**California MLPA Master Plan Science Advisory Team**  
**Summary of SAT Water and Sediment Quality Evaluation of Round 2**  
**NCRSG Draft MPA Proposals for the MLPA North Coast Study Region**  
*Revised June 21, 2010*

**Figure 4. Ruby Draft MPA Proposal 1: Scores for coastal MPAs with water quality concerns and opportunities and the proposal’s average score**

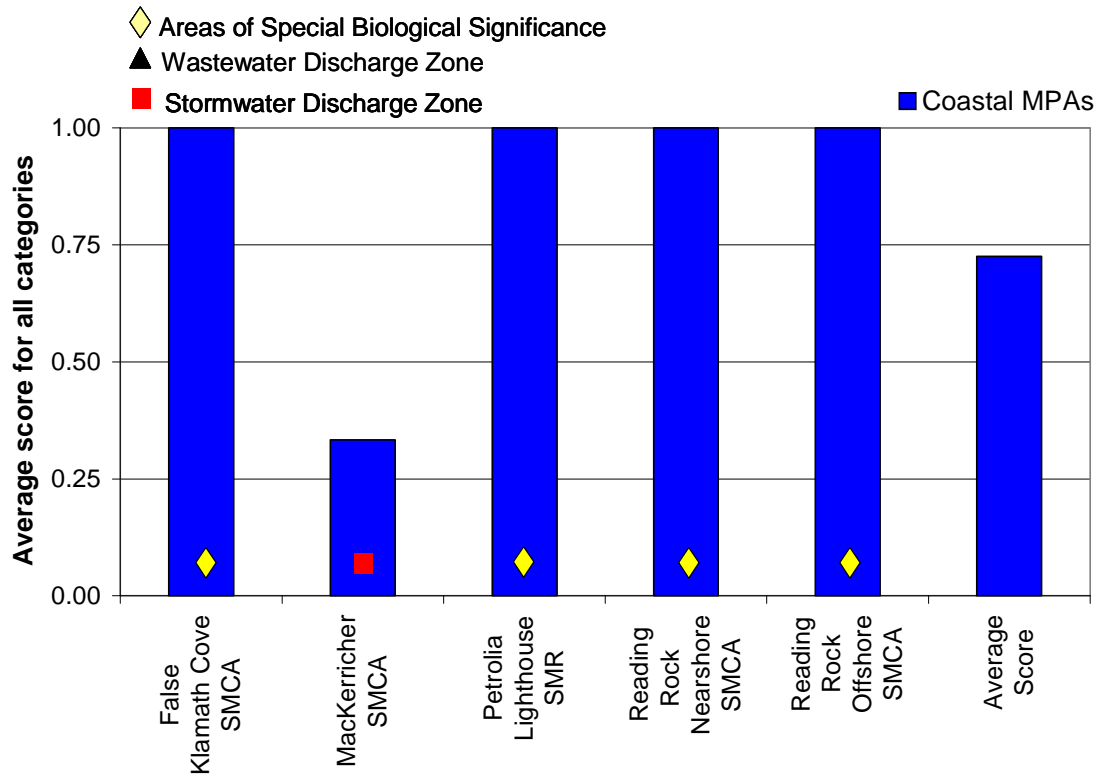
Nearly 83% of the Ruby 1 MPAs located in bays and estuaries scored well (1.00); only one of six MPAs located in bays and estuaries scored poorly. The Humboldt Bay SMRMA was co-located adjacent to Arcata’s urban stormwater discharge areas and scored a 0.25. Additionally this MPA was also co-located with an intermediate wastewater discharge outfall operated by the city of Arcata in the northeast portion of the bay. There are also aquaculture activities nearby but outside the MPA, which should be considered.

The average score for Ruby 1 coastal MPAs is 0.73 and the weighted score is 0.73 (Appendix B). There were 16 of 17 (94%) coastal MPAs that scored 0.67 or higher. There were also 4 of 17 coastal MPAs that were entirely co-located within an ASBS (Figure 4). Three of these MPAs were co-located within Redwood National and State Park ASBS. The fourth MPA was co-located within the Kings Range National Conservation Area ASBS. Only one coastal MPA scored lower than 0.67 (MacKerricher SMCA). The MacKerricher SMCA was located within an urban stormwater discharge drainage area near MacKerricher State Park in Fort Bragg. A potential solution to improving the MacKerricher SMCA’s score would be to move the boundary north of the urban stormwater discharge drainage area.

**Figure 6. Sapphire Draft MPA Proposal: Scores for coastal MPAs with water quality concerns and opportunities and the proposal's average score**

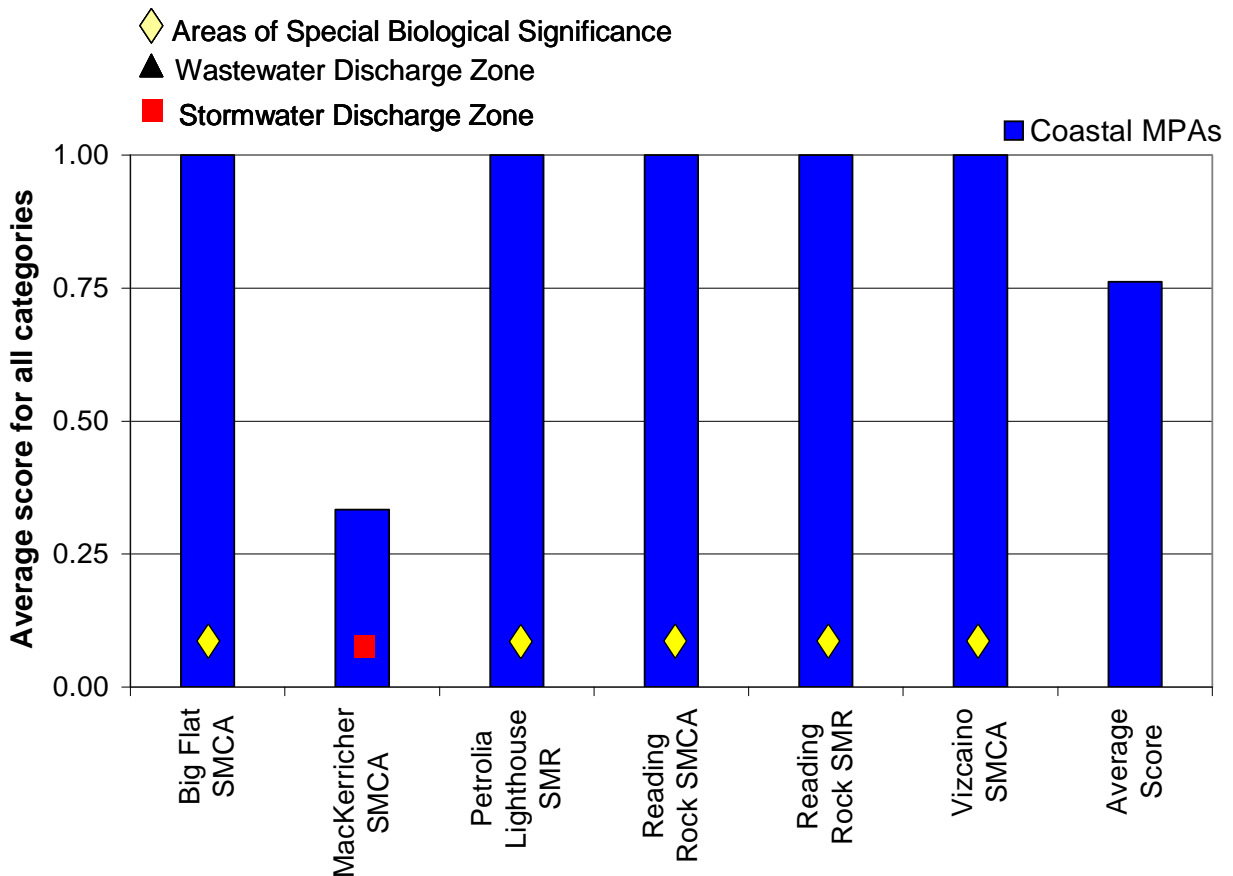
Nearly 83% of Sapphire 1 MPAs located in bays and estuaries scored well (1.00); only one of six MPAs located in bays and estuaries scored poorly. The Humboldt Bay SMRMA was co-located adjacent to Arcata’s urban stormwater discharge areas and scored a 0.25. Additionally, this MPA was also co-located with an intermediate wastewater discharge outfall operated by the city of Arcata in the northeast portion of the bay. There are also aquaculture activities nearby but outside the MPA, which should be considered.

The average score for Sapphire 1 coastal MPAs is 0.76 and the weighted score is 0.75 (Appendix D). There were 13 of 14 (93%) coastal MPAs that scored 0.67 or higher. There were also 5 of 14 (36%) coastal MPAs that were entirely co-located within an ASBS (Figure 6). Three of these MPAs were co-located within Redwood National and State Park ASBS. The fourth and fifth MPA were co-located within the Kings Range National Conservation Area ASBS. Only one coastal MPA scored lower than 0.67 (MacKerricher SMCA). The MacKerricher SMCA was located within an urban stormwater discharge drainage area near MacKerricher State Park in Fort Bragg. A potential solution to improving the MacKerricher

SMCA's score would be to move the boundary north of the urban stormwater discharge drainage area.
